UNITED STATES PATENT AND TRADEMARK OFFICE

10/577,411

Office Action Summary	Application No. 10/577,411	Applicant(s) STEGHAFNER, HERBERT	
	Examiner Trinh Vo Dinh	Art Unit 2821

DETAILED ACTION

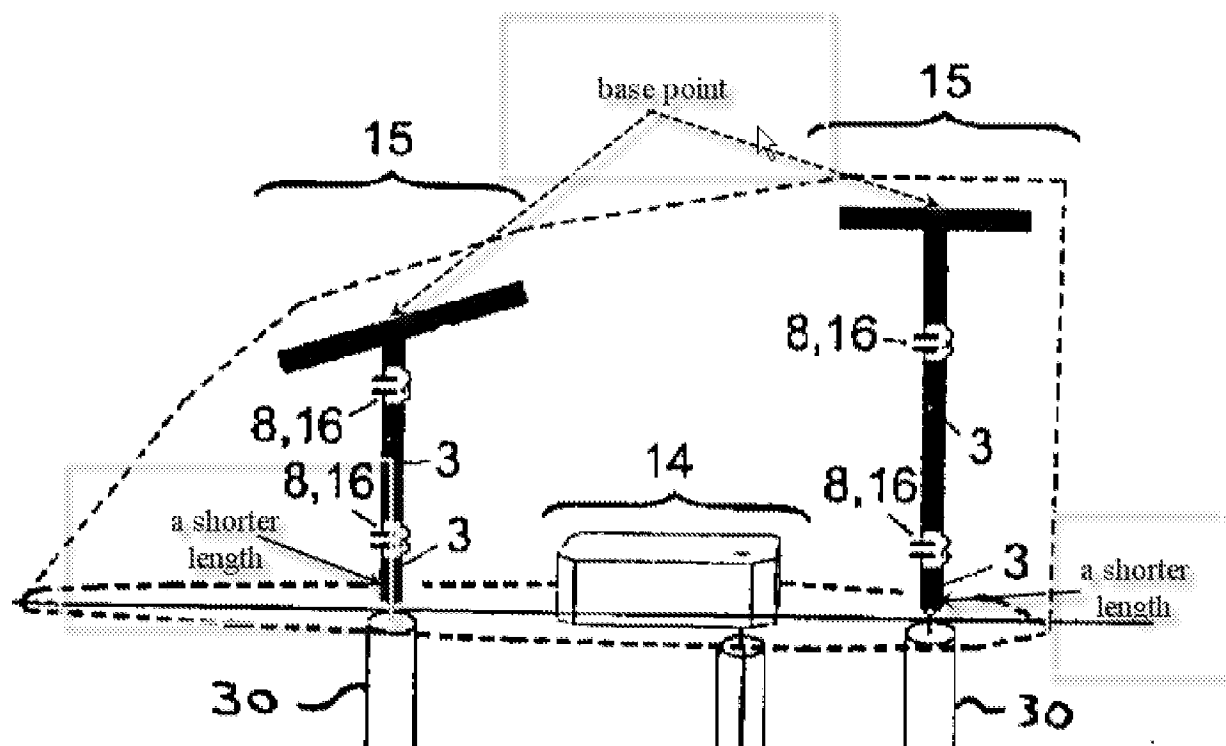
4. Claims 1-4 and 6, as the best understood, are rejected under 35 U.S.C. 102(e) as being anticipated by Lindenmeier (US 6,917,340 of record).

Respecting claim 1, as the best understood, Lindenmeier discloses an antenna system (in Figs. 5-6) of broad bandwidth comprising a plurality of active, vertical individual antennas (14, 15 in Figs. 5-6) with an electrically-active antenna height adapted to the respective received frequency range (col. 6 lines 11-26) wherein the mutual electromagnetic coupling between the individual antennas which are positioned at a small spacing distance, is minimized (col. 4 line 44 to col. 5 line 4) wherein conductor portions (3) between intermittent impedance elements (8, 16, 30) of each individual antenna (15) are of a shorter length (as shown in the below drawing) with increasing distance from a base point (as shown in the below Drawing).
